CDM: Recommendation Form for Small Scale Methodologies (version 01)
(To be used for presenting questions/proposals/amendments to the simplified methodologies for small-scale CDM project activity categories)

Date of SSC WG meeting:	22–25 August 2011, SSC WG 33
Title/Subject (give a small title or specify the subject of your submission, maximum 200 characters):	Clarification on the applicability of AMS-II.H to project activities promoting waste-heat based chillers
Indicative methodology to which your submission relates (refer the items of Appendix B of the Simplified Modalities and Procedures), if applicable.	AMS.II-H. “Energy efficiency measures through centralization of utility provisions of an industrial facility”
Name of the authors of the query:	Cynthia Hendrayani / Ravi Desai Institution: cynthia.hendrayani@gmail.com , desai@g3.co.id

SSC-Submission number	SSC_550
Date when the form was received at UNFCCC secretariat	25 August 2011
Date of transmission to the EB	25 August 2011
Date of posting in the UNFCCC CDM web site	25 August 2011

Illustration of Situation Without the Project

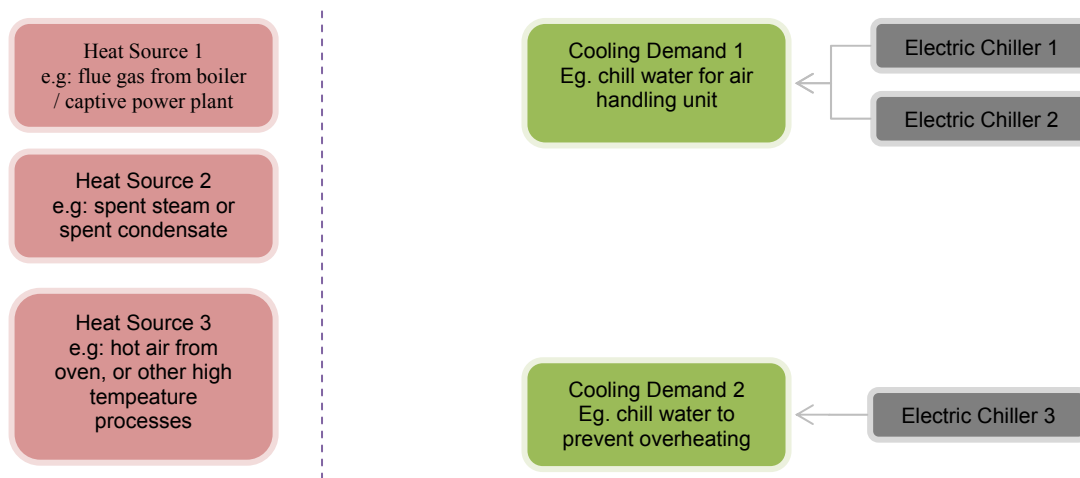
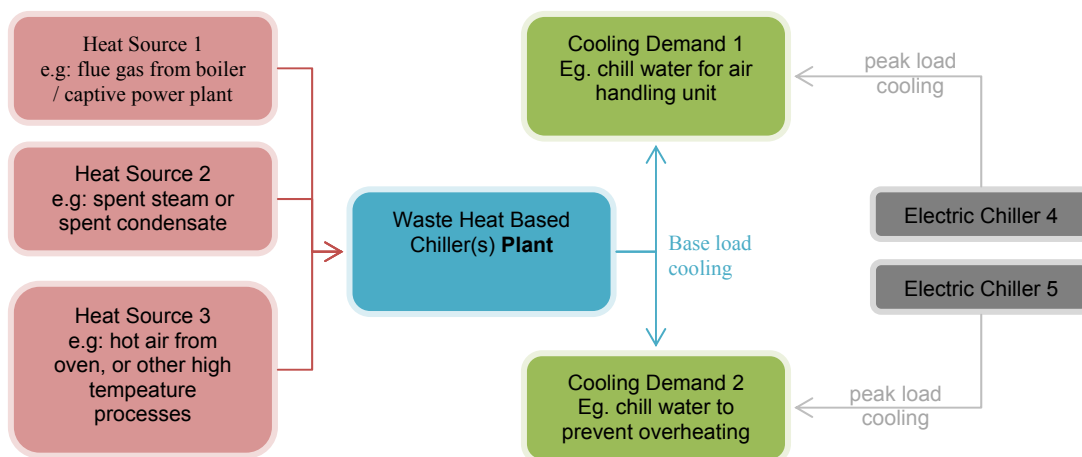
Without the Project There exists (unused) heat source(s) within vicinity of a target user with cooling demand.

The heat sources may be tapped from: (a) flue gas of an operating boiler or captive power plants; (b) spent steam or condensates; (c) hot air from oven, or other high temperature processes; (d) combinations of all of these sources.

The cooling demand can be: (a) chill water for air handling units, or (b) chill water for various other uses, eg. jacket water for temperature control, etc. Without the Project, this chill water demand will be fulfilled using (one or more) electric chiller(s) sized accordingly.
